R20TS0571EJ0101

CS+ Code Generator for RL78, e² studio Code Generator Plug-in, Applilet3 Coding Assistance Tool for RL78

1. User option byte (000C1H/010C1H) LVD off setting values

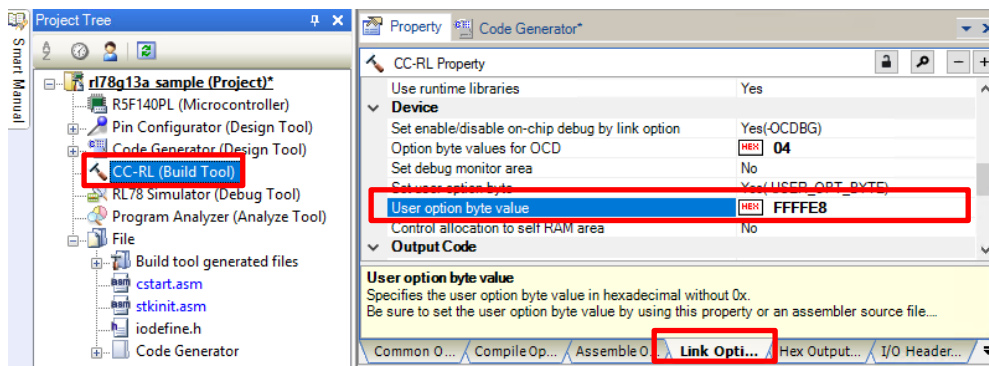
The user option byte (000C1H/010C1H) setting values for LVD off are incorrect.

- (2-1) For CCRL

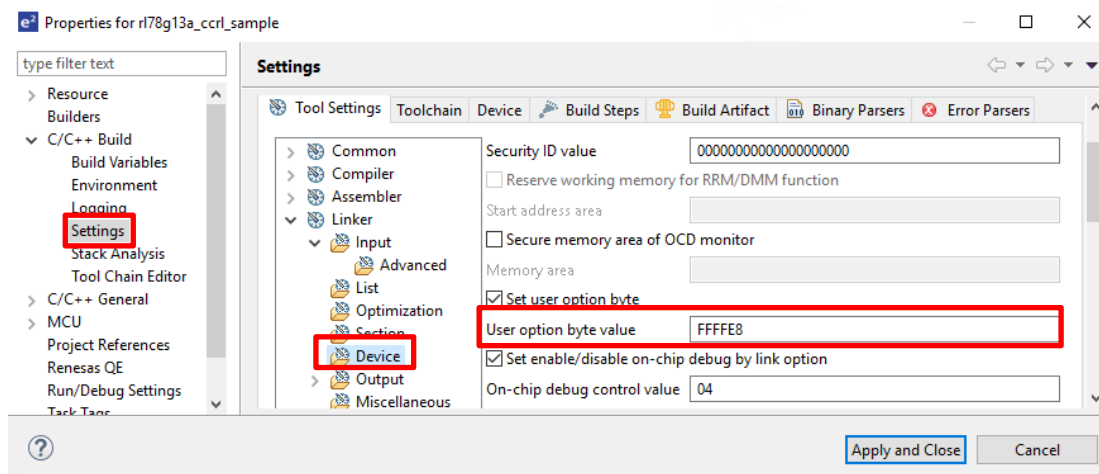
Open the properties. Then, from [Settings] - [Device], change the user option byte value FFFFE8 to FF~~F~~3E8.

- (2-2) For GCC

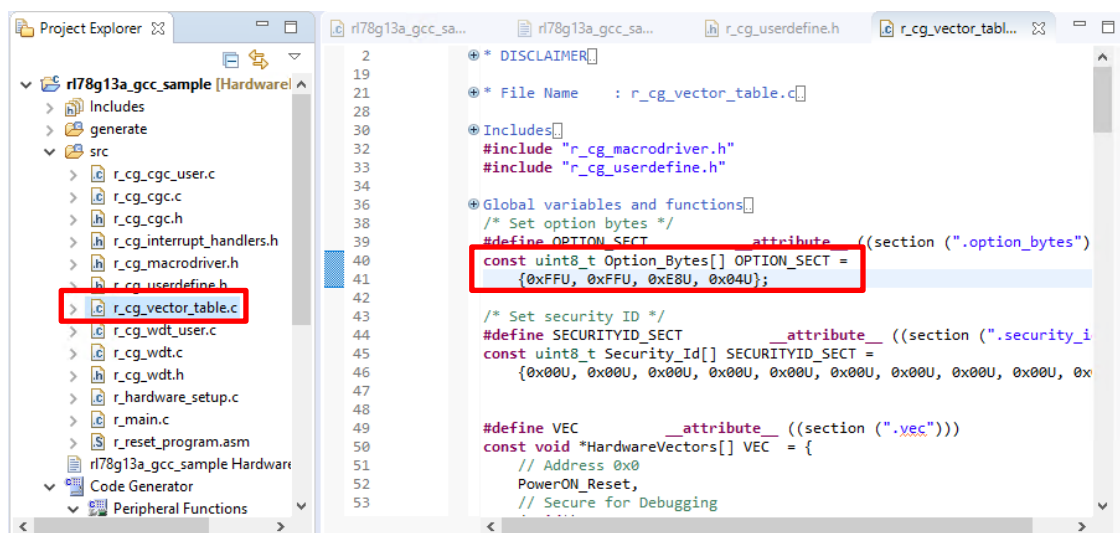
Open r_cg_vector_table.c, and then change {0xFFU, 0x~~F~~FU, 0xE8U, 0x04U} to {0xFFU, 0x~~F~~3U, 0xE8U, 0x04U}.
